ENGINE - AIR - TO ANNOUNCE THE INTRODUCTION OF A SPACER AT CLIPPING POINT CP2423 (NO.4 BEARING SCAVENGE VALVE AIR SERVO TUBE) - CATEGORY CODE 7 - MOD.ENG-75-0042

V2500-ENG-75-0042

Location of clipping point 2423
Fig.1

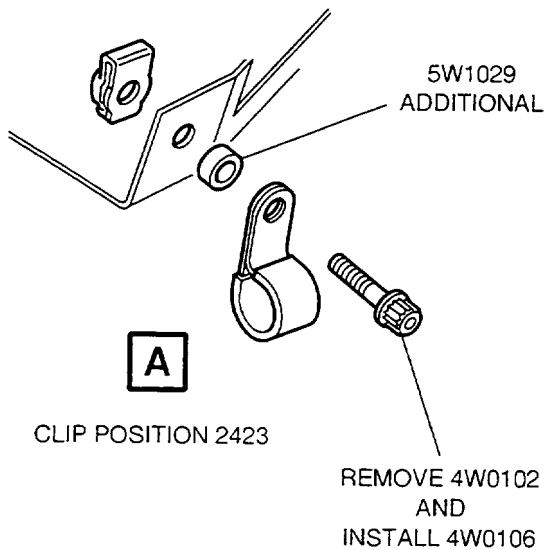
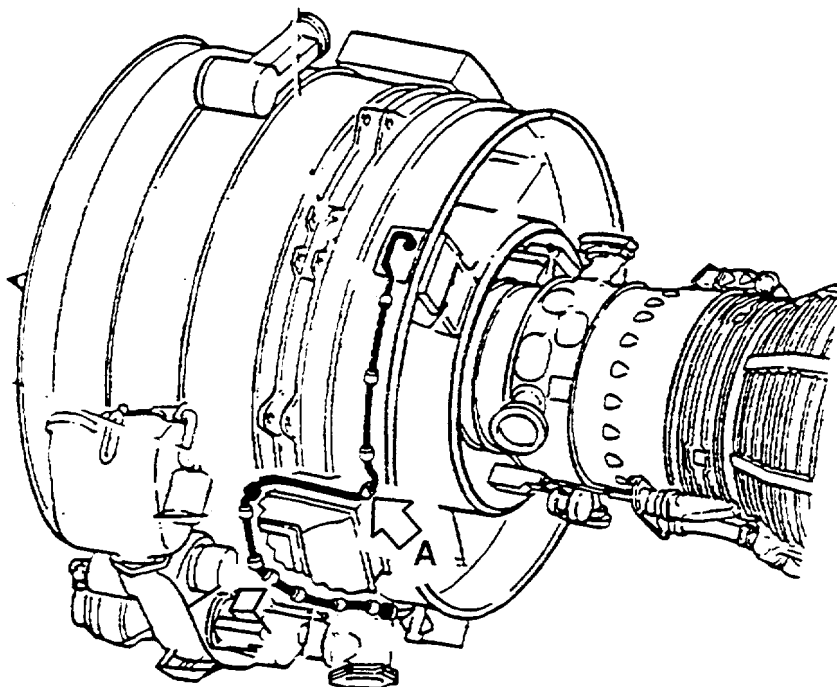
Possible misalignment of the No.4 bearing scavenge valve air servo tube with the support bracket at CP2423.

- (1) This Service Bulletin introduces a 5 mm spacer at CP2423, positioned between the support bracket and the pipe clip.
- (2) A longer bolt is introduced to accommodate the additional spacer.

- (1) Locate the No.4 bearing scavenge valve our servo tube clipping point (CP2423) and remove the existing bi-hex bolt (4W0102). Refer to Figures 1 and 2.
- (2) Install the new spacer (5W1029) between the air tube clipping point and the support bracket. Install the new longer bi-hex bolt (4W0106) and torque to 36 to 45 lbfin. (4 to 5 Nm).
